ADDENDUM NO. 2

**MSHP Interoperability Site,
Replace Roof & Renovate Basement and Access,
Support Services Bldg.,
2413 East McCarty St.,
Jefferson City, MO 65101
PROJECT NO. R2508-01**

Bidders are hereby informed that the Construction Plans and/or Specifications are modified as follows:

SHEET TITLE:
**DEMO PLAN -
GROUND LEVEL**

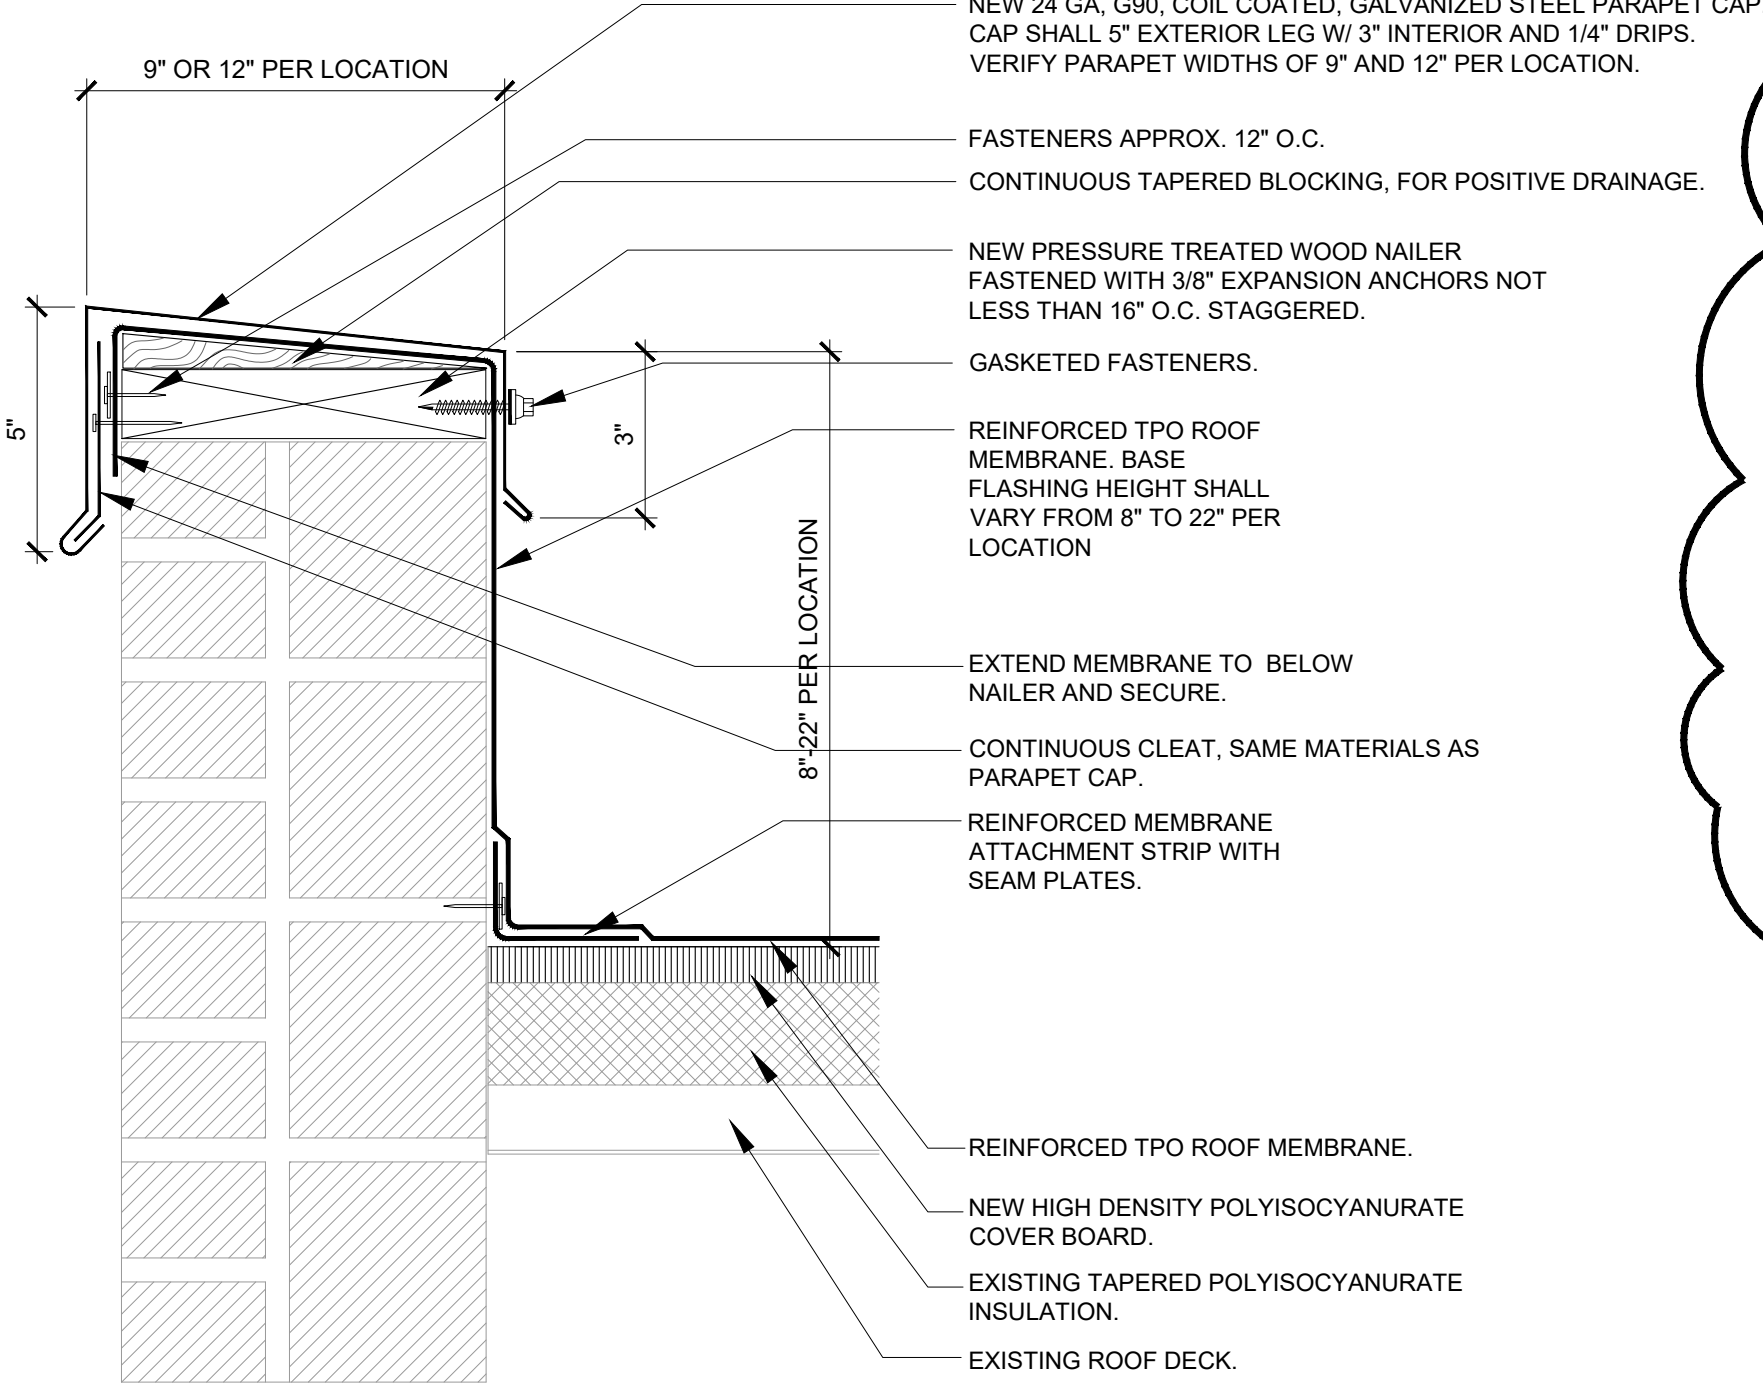
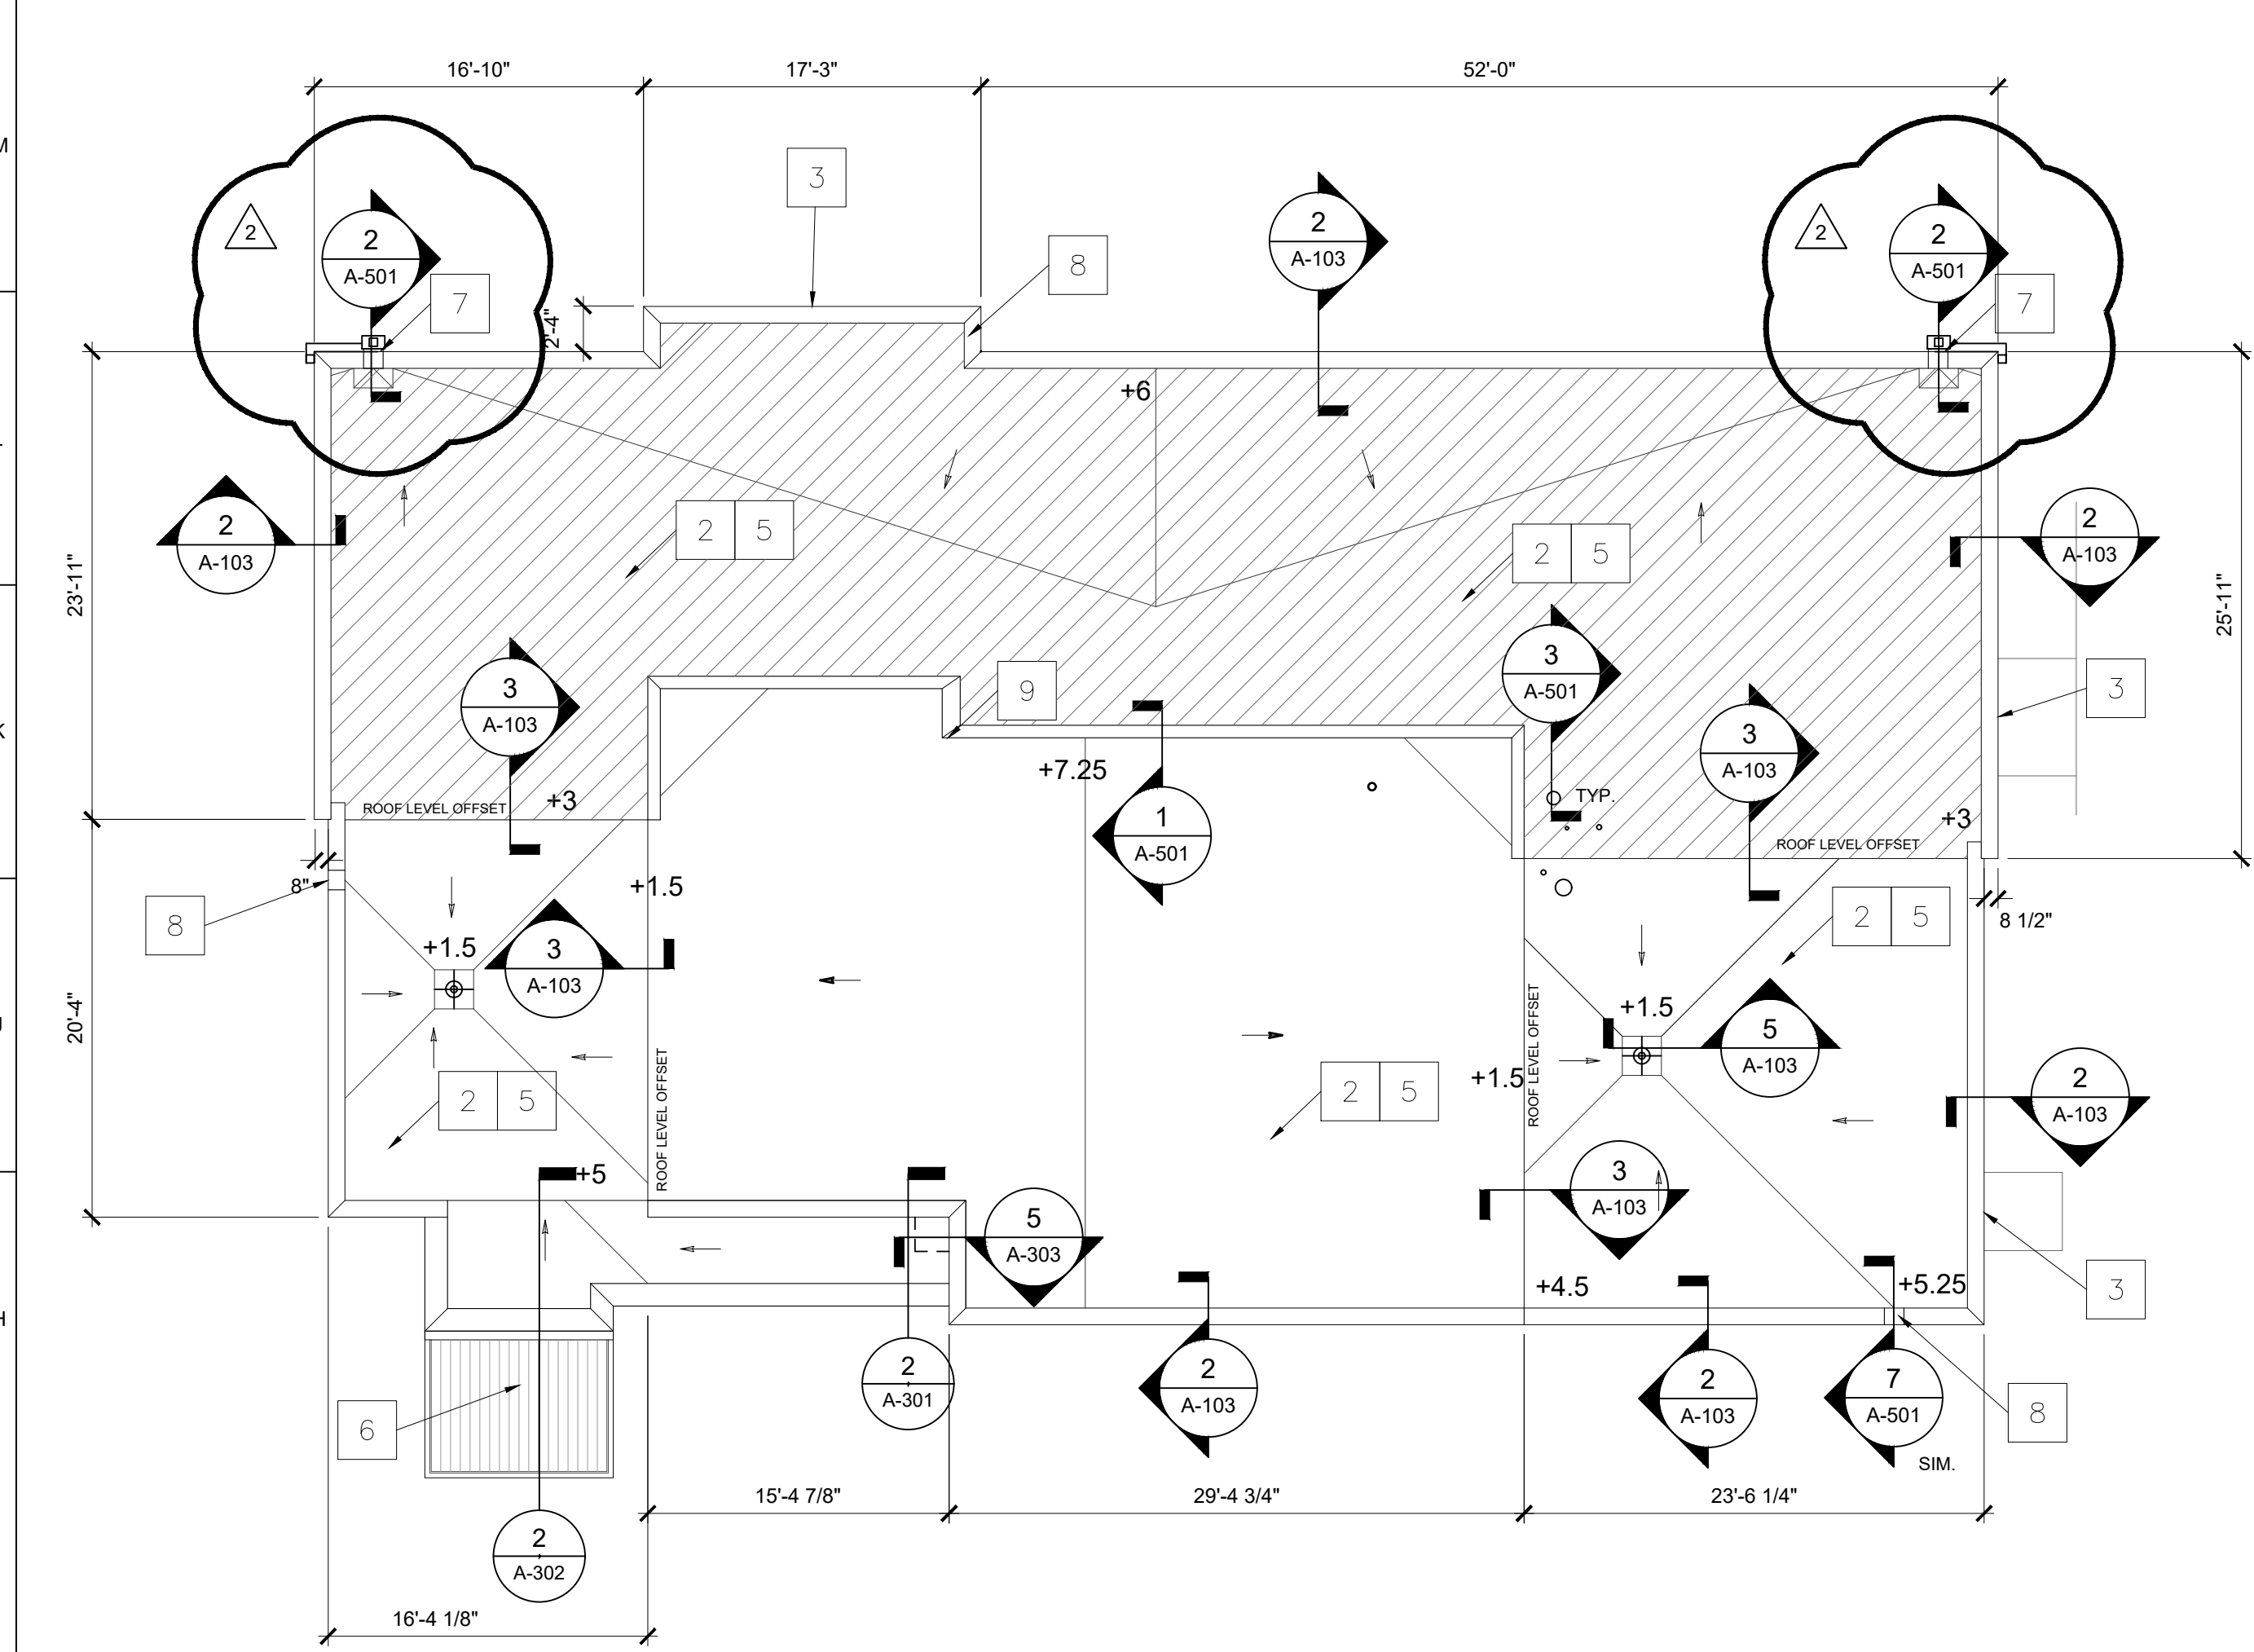
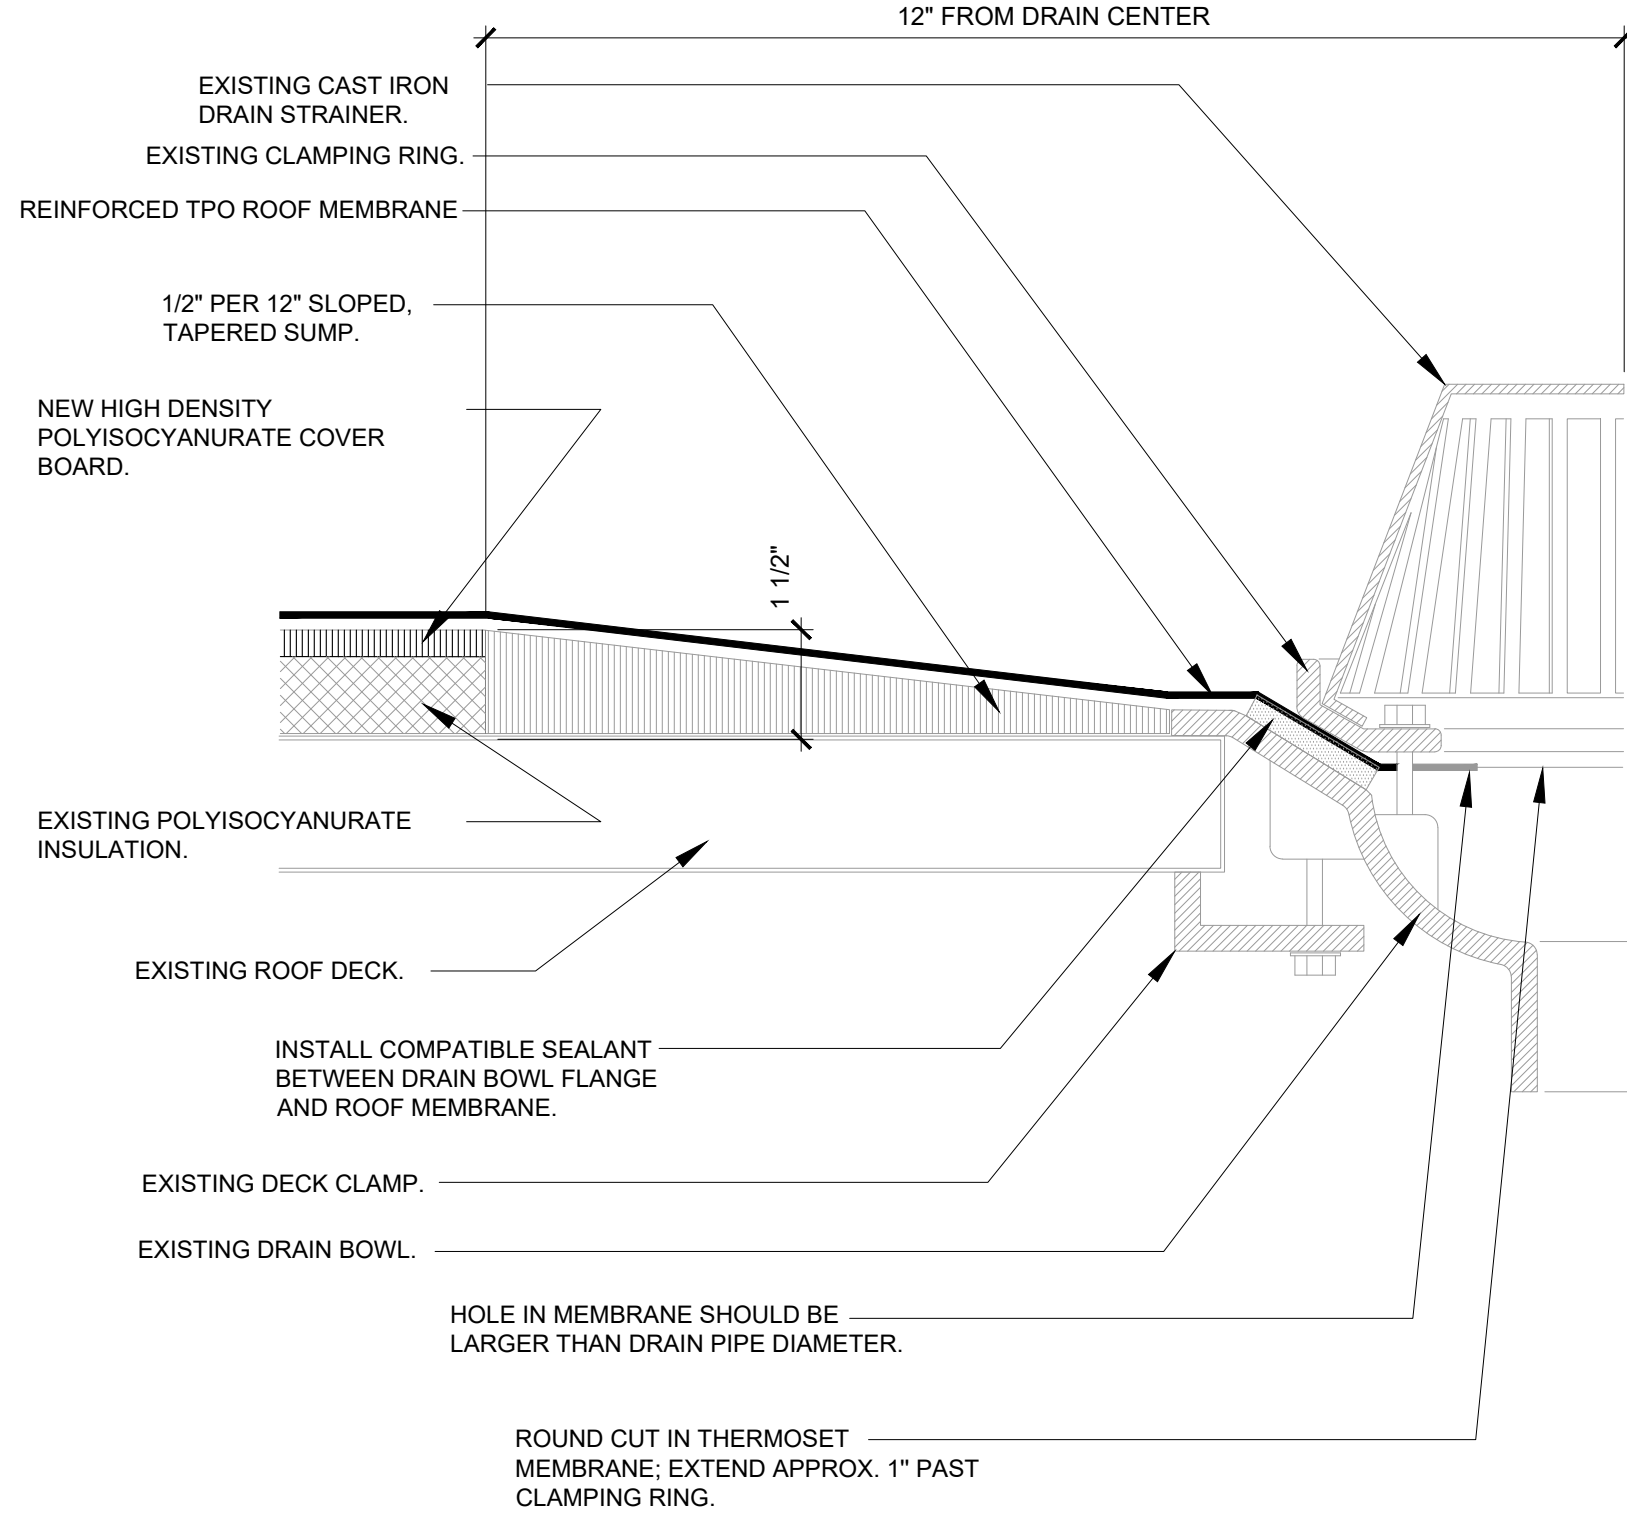
4. *SHEET D102*

- a. ADD Demo existing down spout. Trench to new location. See A102. This occurs on Southeast and Southwest corners.
